**Town of Carmel
60 McAlpin Avenue
Mahopac, NY 10541
RE: 99 Everett Road; Mahopac, NY
300,000 Gallon GST
March 25, 2019
Mr. Rich Franzetti
Engineer
(845) 628-1500 x181
Job No. 319099-C**

GROUND STORAGE INSPECTION REPORT

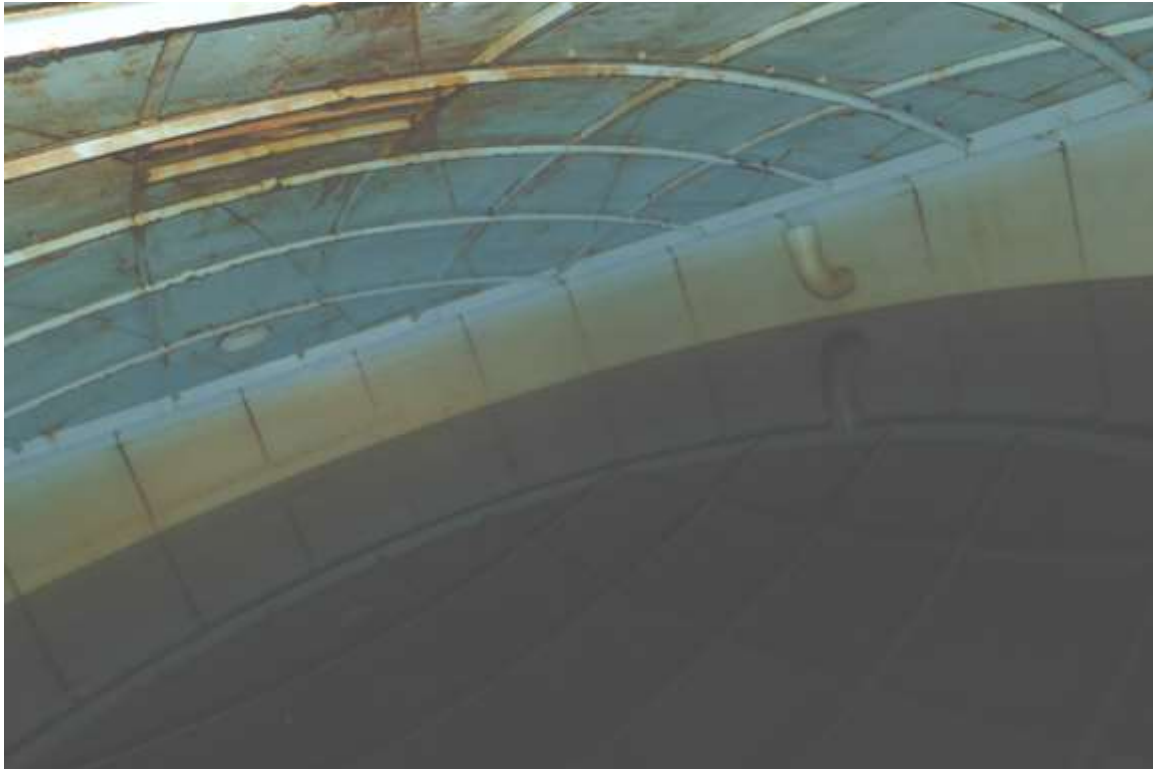
Photos show the tank exterior coating system. We recommend pressure washing the tank exterior and support structure using an anti-fungal biodegradable solution, hand tool cleaning as necessary, then applying a full prime coat of Macropoxy 5000, followed by an intermediate coat of Sherwin Williams Dura-Plate 235, and one (1) full finish coat of Sherwin Williams Acrolon 218 HS.

This work should be performed on an emergency basis.

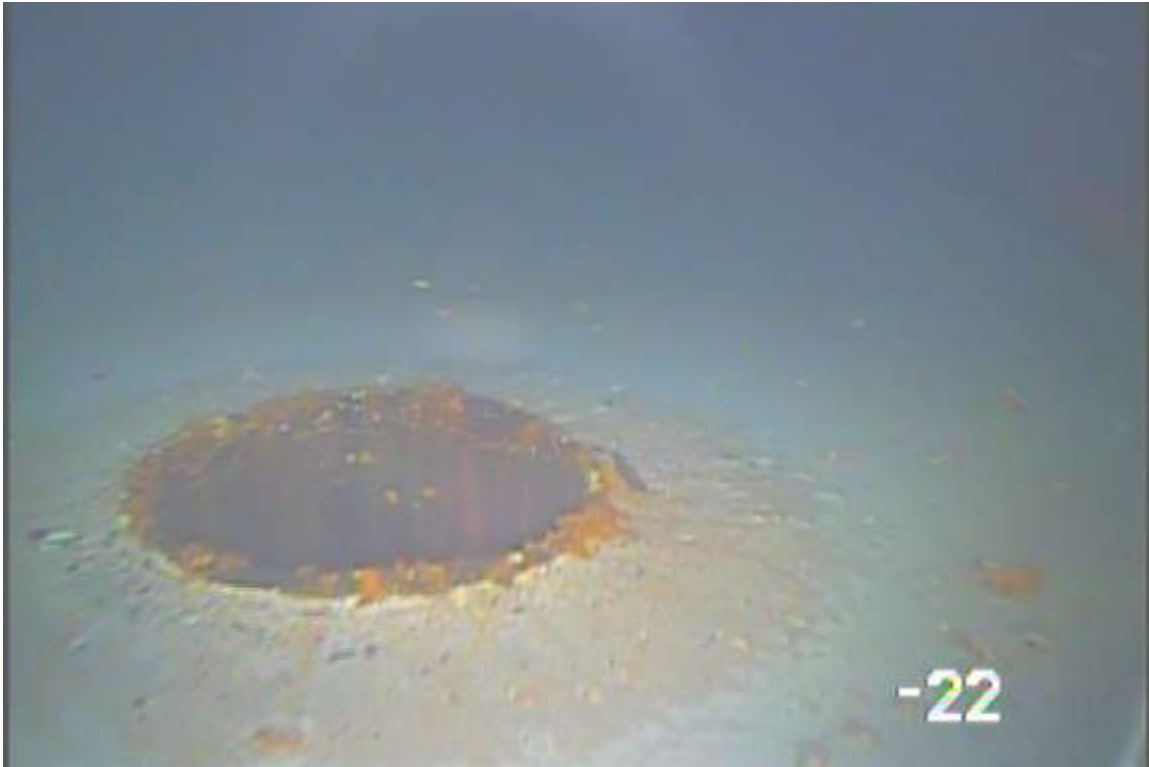
Photo shows the condition of the interior roof. Notice the rust forming at the roof lap seams. We recommend seam sealing using Sikaflex® 1a on all un-welded interior roof lap seams to prevent failure of a new interior liner. This work is to be performed in conjunction with application of new interior liner.
